APPLICATION NO.	FILING DATE	FIRST NAMED INVENTOR	ATTORNEY DOCKET NO.	CONFIRMATION NO.
10/814,610	03/30/2004	Darin G. Schaeffer	8627-190	5422
757 7590 07/19/2007 BRINKS HOFER GILSON & LIONE P.O. BOX 10395 CHICAGO, IL 60610			EXAMINER MILLER, CHERYL L	
			ART UNIT 3738	PAPER NUMBER
			MAIL DATE 07/19/2007	DELIVERY MODE PAPER

Office Action Summary	Application No. 10/814,610	Applicant(s) SCHAEFFER, DARIN G.	
	Examiner Cheryl Miller	Art Unit 3738

DETAILED ACTION

Attachment # 1 (marked up) claims 23-30

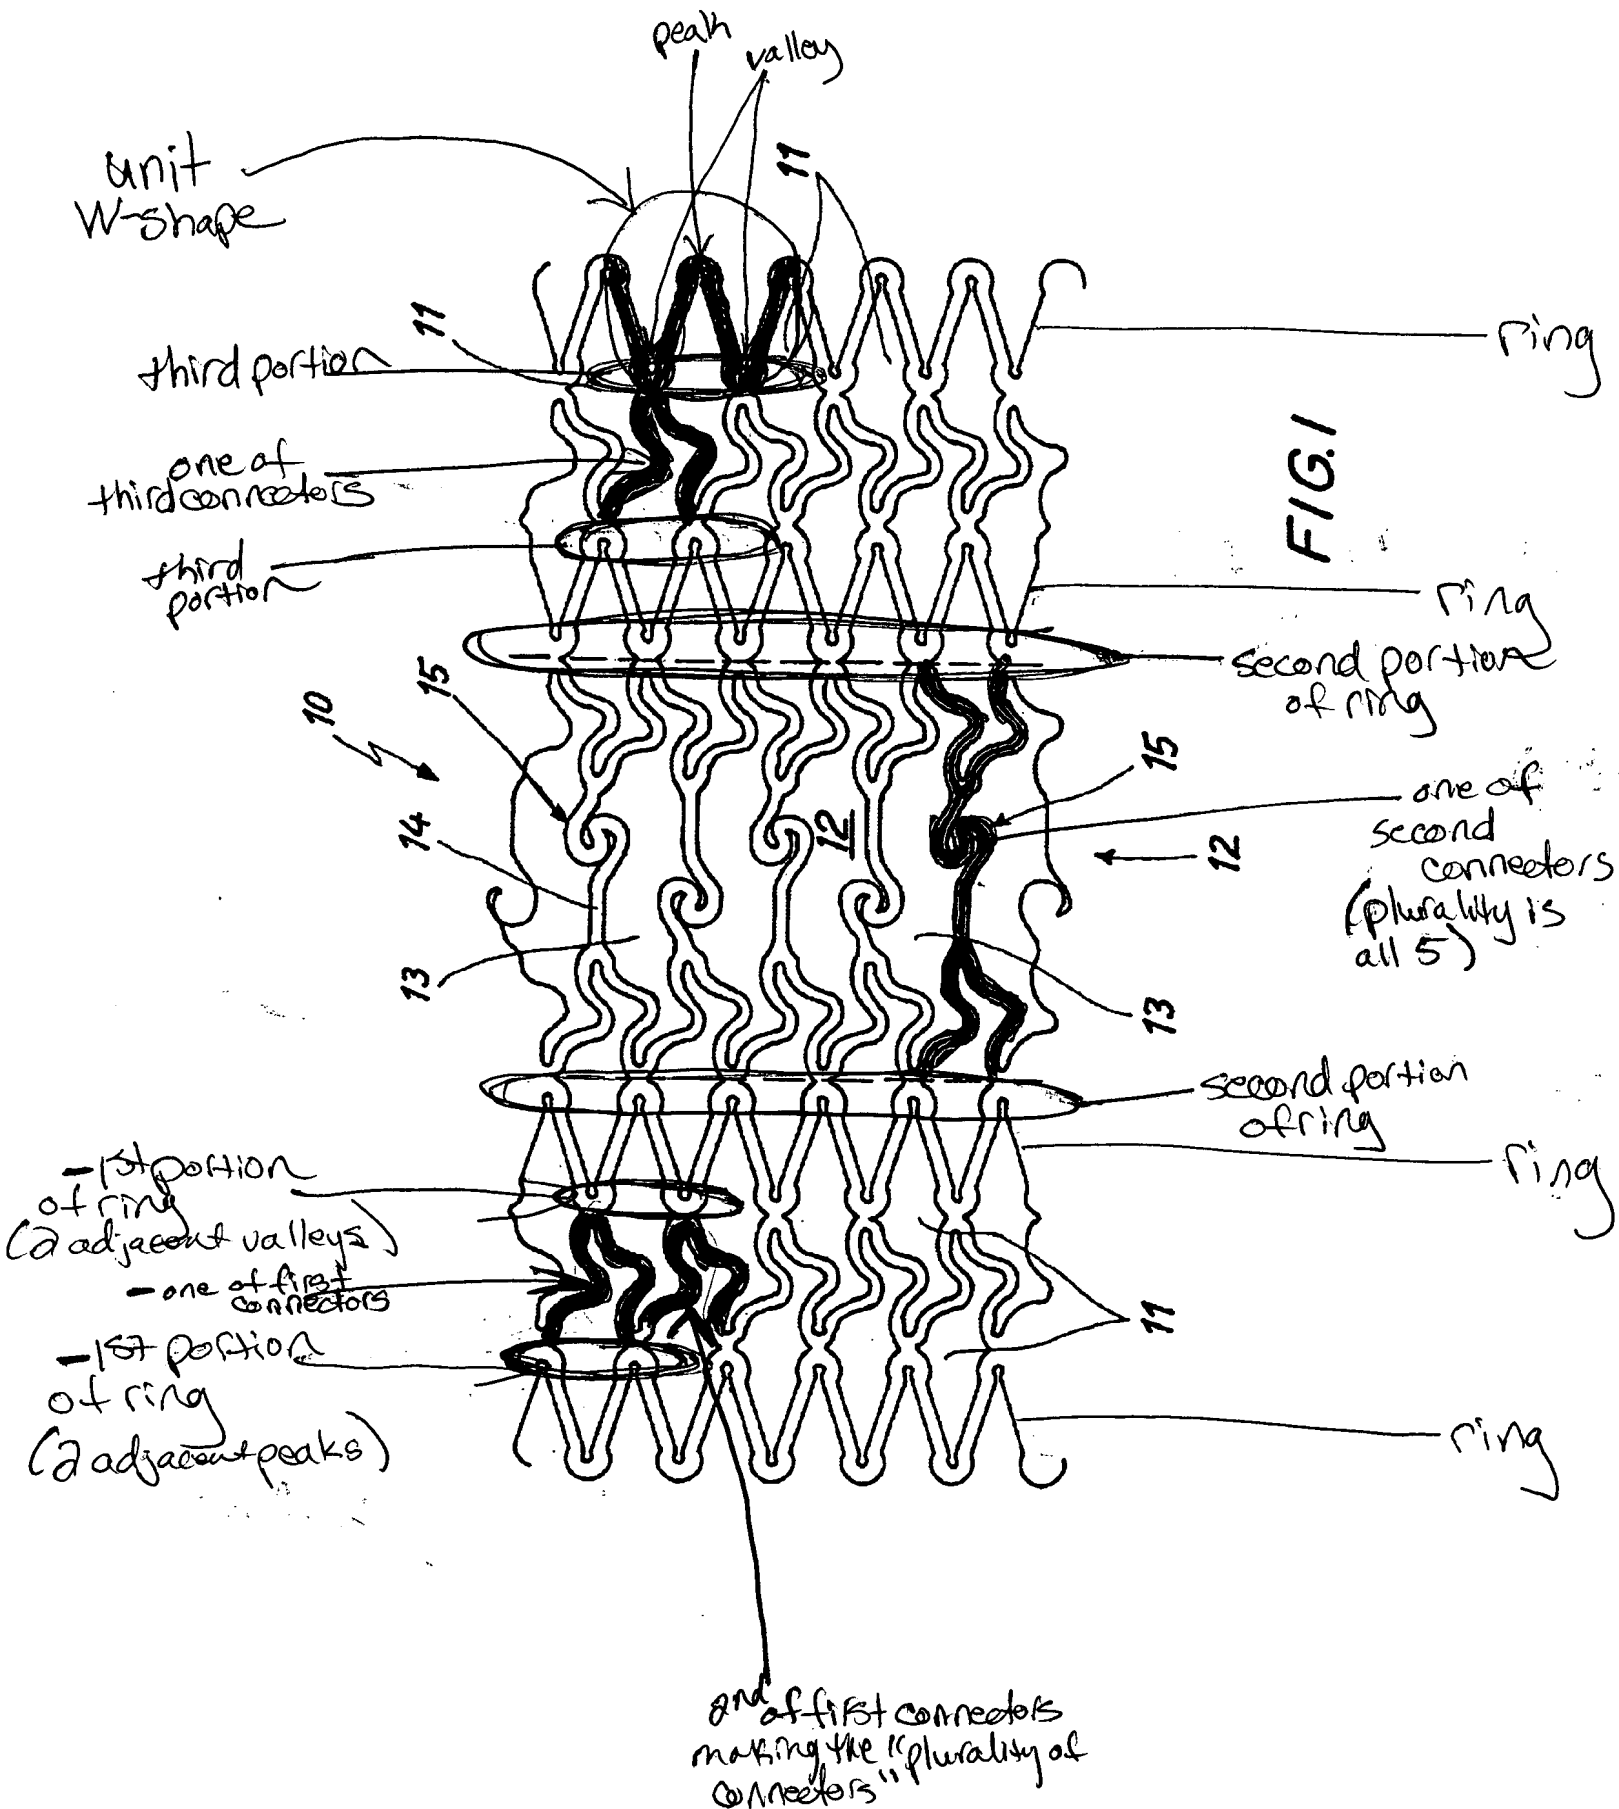
Claims 23-30 are rejected under 35 U.S.C. 102(b) as being anticipated by Von Oepen et al. (EP 0 958 794 A2, cited in IDS, see US 6,652,573 B2 for English equivalent). Von Oepen discloses a stent (10; fig.1) comprising a series of rings forming serpentine patterns and comprising a plurality of units, the units comprising first and second lateral arms and a central region between the arms, the central region having a peak between two valleys, each unit inverted with respect to the circumferentially adjacent unit, the lateral arms of each unit shared, a first portion of the rings (2 adjacent peaks of a ring considered the “first portion”, see attachment 1) being joined by a first plurality of connectors (“plurality of connectors” considered 2 adjacent connectors, highlighted in attachment 1) having an undulation, a second portion of the rings (all five peaks of one ring) joined by a second plurality of connectors (all five 14+15 connectors seen in fig.1) having an undulation (15), a third portion of the rings (2 adjacent peaks of one ring)

joined by a third plurality of connectors (2 adjacent connectors) having an undulation, wherein the undulation of the second connector (15) is axially displaced from its circumferentially adjacent connector (15) and an undulation of the first and third connectors axially aligned with circumferentially adjacent connectors (see attachment 1, fig.1). Von Oepen discloses the second connectors (15; 5 of them in number) to be double in number to the first and third connectors (only 2 of each the first and third connectors are considered the “plurality of connectors”), therefore, there are double the amount of second connectors). Von Oepen discloses the units to comprise a W-shape (see attachment 1). Von Oepen discloses the undulation of the connectors to be a u shaped bend flanked with u bends (see fig.1).

FIG. 1

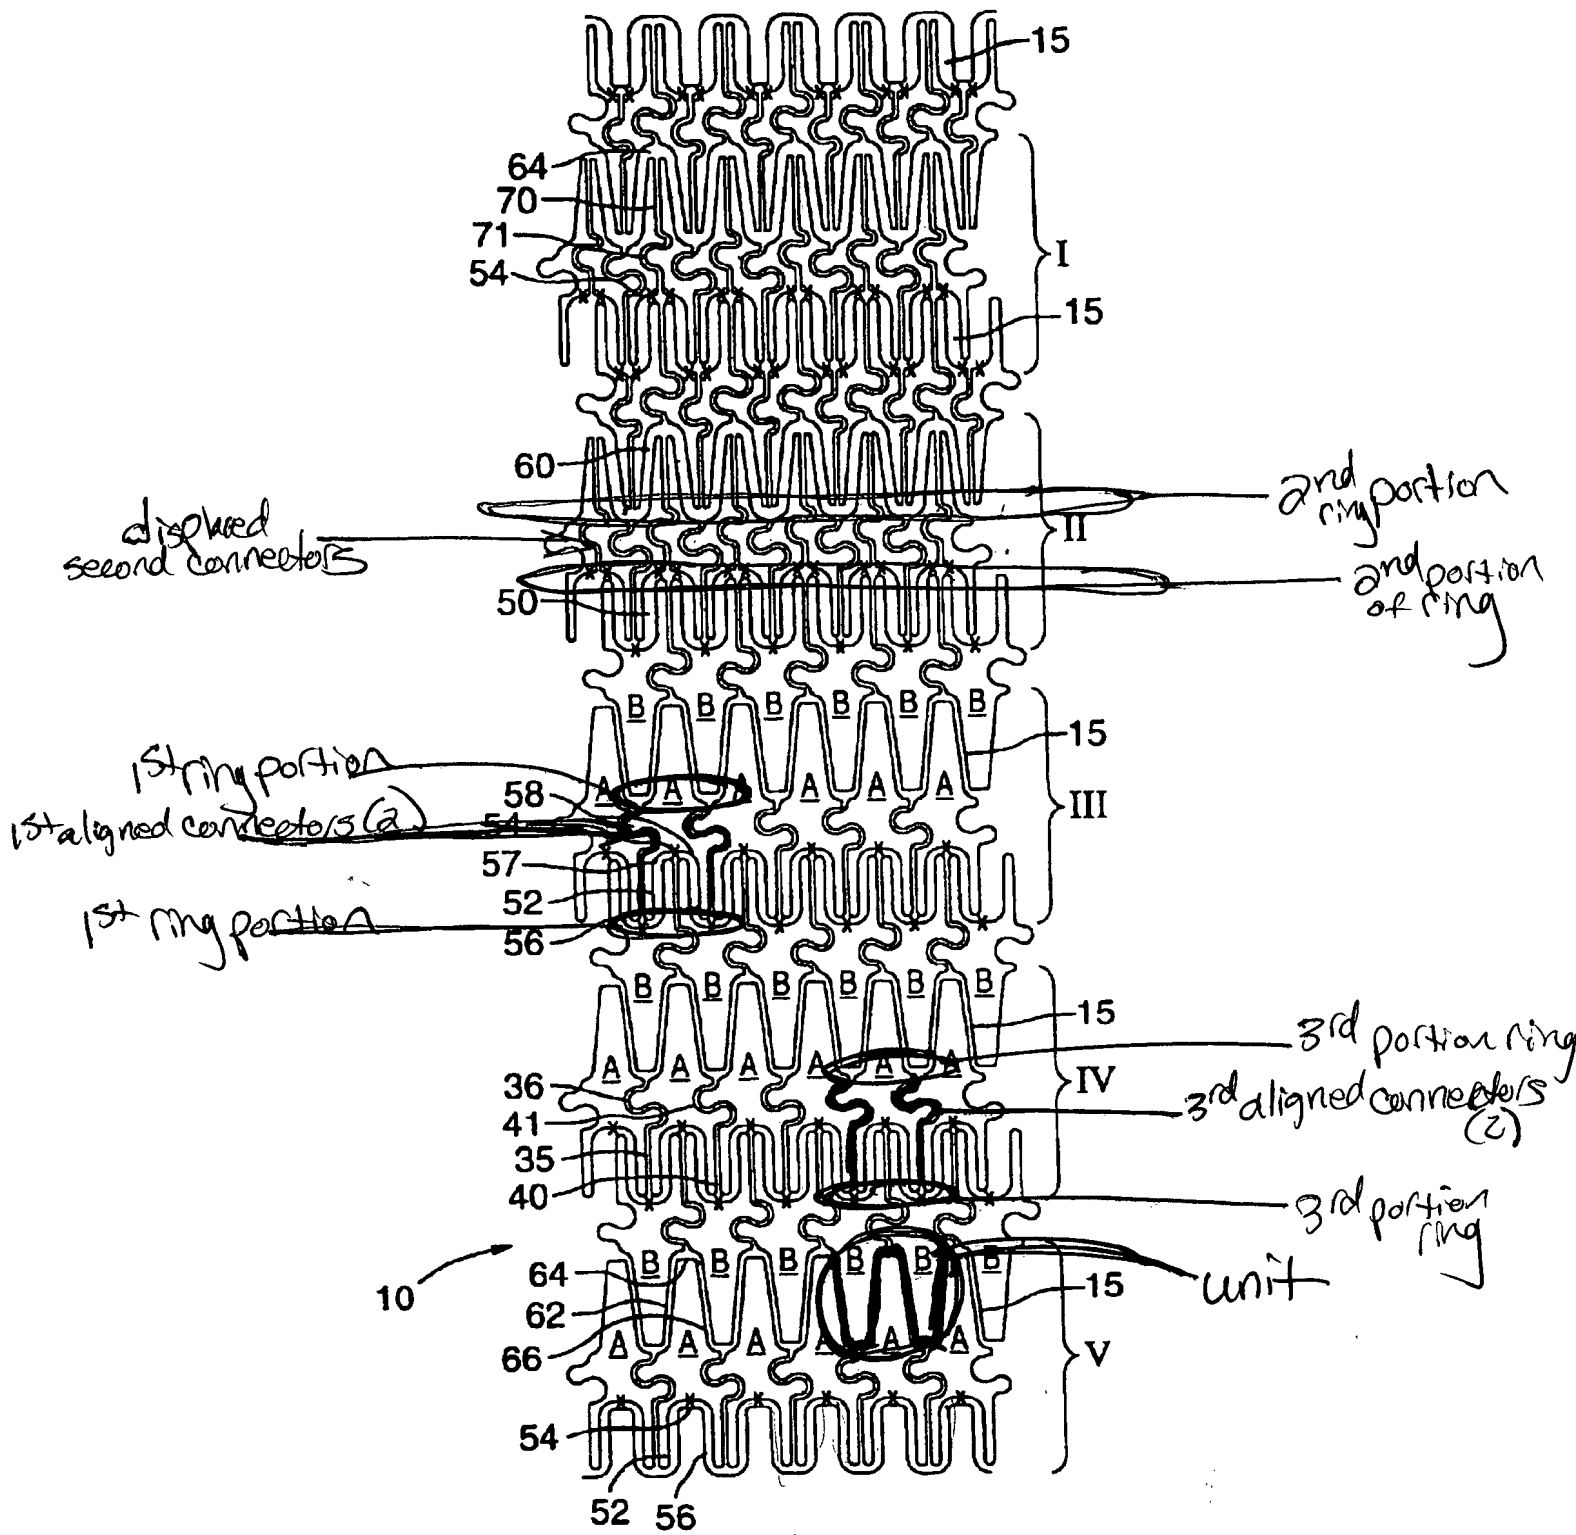
Claims 23-30 are rejected under 35 U.S.C. 102(e) as being anticipated by Levinson et al. (US 6,352,552 B1, cited previously). Levinson discloses a stent (20; fig.1) comprising a series of rings forming serpentine patterns and comprising a plurality of units, the units comprising first and second lateral arms and a central region between the arms, the central region having a peak between two valleys, each unit inverted with respect to the circumferentially adjacent unit, the lateral arms of each unit shared, a first portion of the rings (2 adjacent peaks of a ring considered the “first portion”, see attachment 2) being joined by a first plurality of connectors (“plurality of connectors” considered 2 adjacent connectors, highlighted in attachment 2) having an undulation (72), a second portion of the rings (all six peaks of one ring) joined by a second plurality of connectors (all six displaced connectors seen in fig.1) having an undulation, a third portion of the rings (2 adjacent peaks of one ring) joined by a third plurality of connectors (2 adjacent connectors 96, 98) having an undulation, wherein the undulation of the second connector is

axially displaced from its circumferentially adjacent connector and an undulation of the first and third connectors axially aligned with circumferentially adjacent connectors (see attachment 2, fig.1). Levinson discloses the second connectors (6 of them in number) to be double in number to the first and third connectors (only 2 of each the first and third connectors are considered the “plurality of connectors”, therefore, there are double the amount of second connectors). Levinson discloses the units to comprise a W-shape (see attachment 2). Levinson discloses the undulation of the connectors to be a u shaped bend flanked with u bends (see fig.1).
